# UNITED STATES PATENT AND TRADEMARK OFFICE

APPLICATION NO.	FILING DATE	FIRST NAMED INVENTOR	ATTORNEY DOCKET NO.	CONFIRMATION NO.
10/802,194	03/17/2004	Roman Heckt	10541-1989	3418

**Office Action Summary**

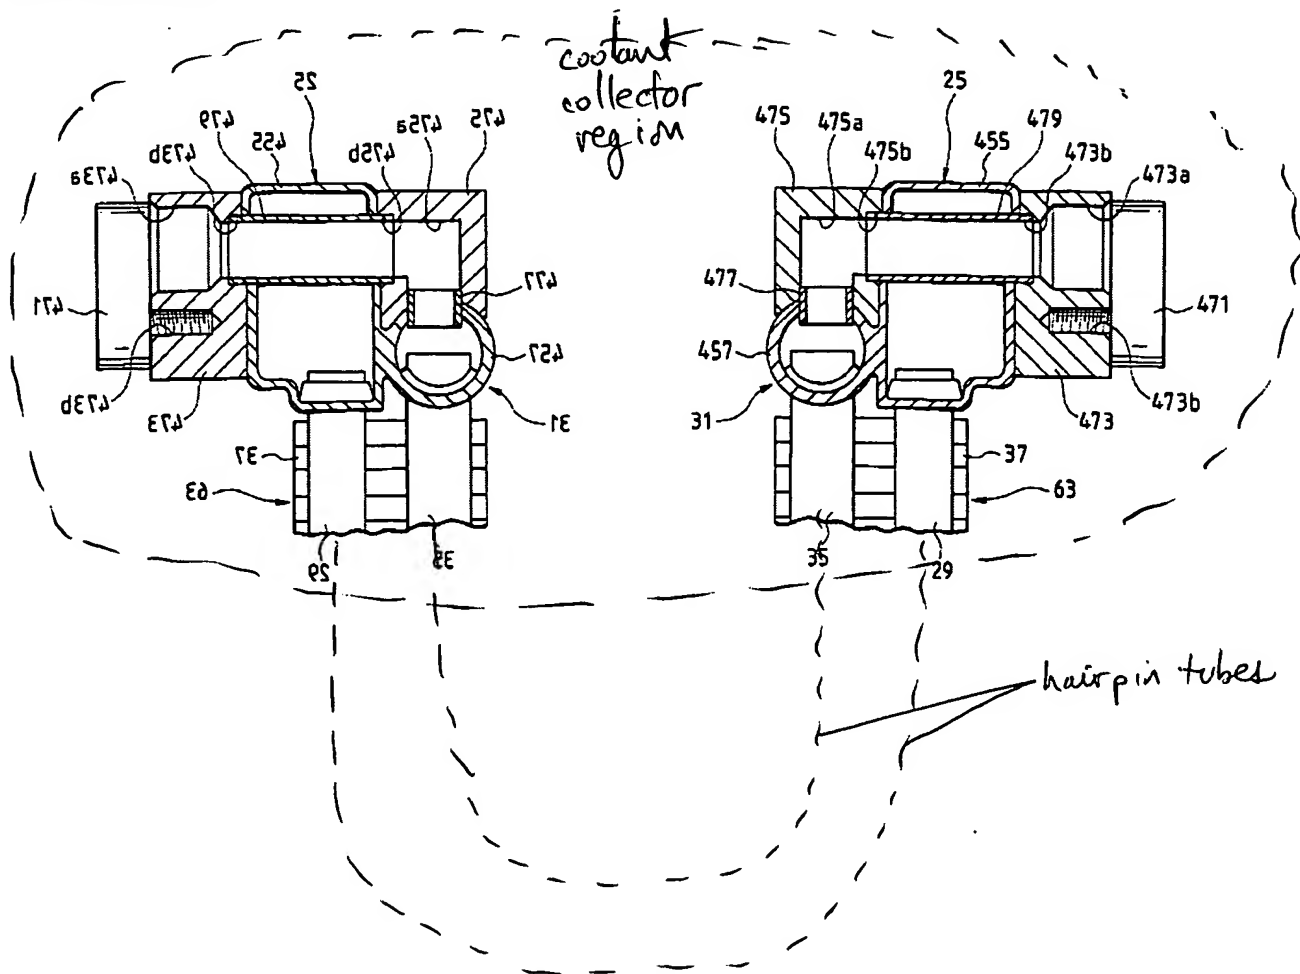
By comparison of Figure 3 of McKibben, that discloses a "straight-through" heat exchanger with headers 13 and 14 at opposite ends (similar to what Makino shows in Figures 24-27), and Figure 5 of McKibben (showing a "hairpin type" heat exchanger with both headers 22 and 25 adjacent one another at one end of the heat exchanger), the art recognized equivalence of these two types of heat exchangers is established. To have made the tubes 35 and 29 in Makino Figures 24-27 as the "hairpin" type rather than the "straight-through" type would have been obvious to one of ordinary skill in the art to advantageously fit the heat exchanger in a smaller air duct. As such, the inlet header and outlet header (depicted in either Figures 24 or 27 of Makino) would be located at the same end of the heat exchanger denoted for purposes of rejection the "coolant collector region." See the illustration below.
